Subject: FRONT DOOR INTERFERES REAR DOOR GARNISH	Bulletin No.: 09-007/21
	Last Issued : 04/15/2021

APPLICABLE MODEL(S)/VINS

2019-2020 Mazda3 5-door HB (Japan built) with VINS lower than JM1BP*****158118 (produced before November 29, 2019)

Old	New
Clip		
Hole at the door panel

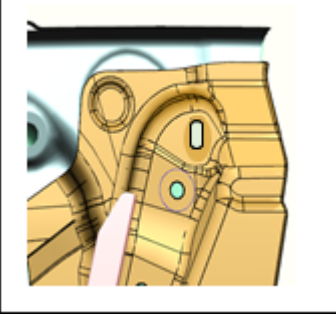
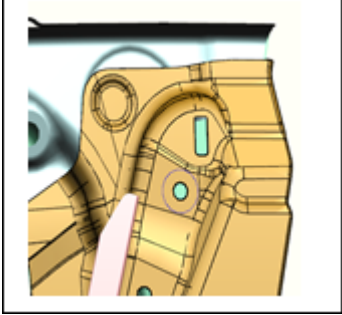
- Phase 1
 - Adhesive has been added between the front door glass run channel and the door panel.
- Phase 2
 - The shape of the front door glass run channel has been changed so as not to make contact with the rear garnish.
 - The shape of the clip at the rear side of the front door glass run channel has been changed for stronger fixing and the hole at the door panel has been changed accordingly.

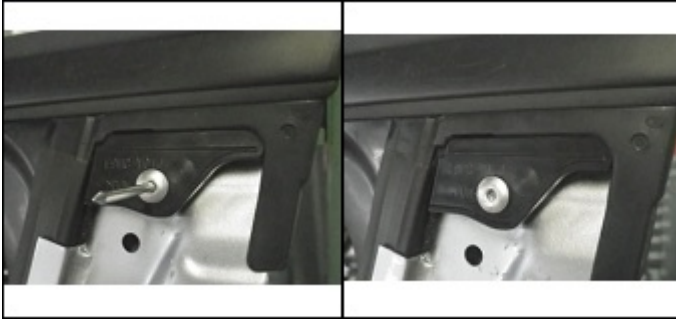
b. Remove the clip plate from a modified front door glass run-channel.

c. Cut the clip off which does not fit with the hole at the door panel.
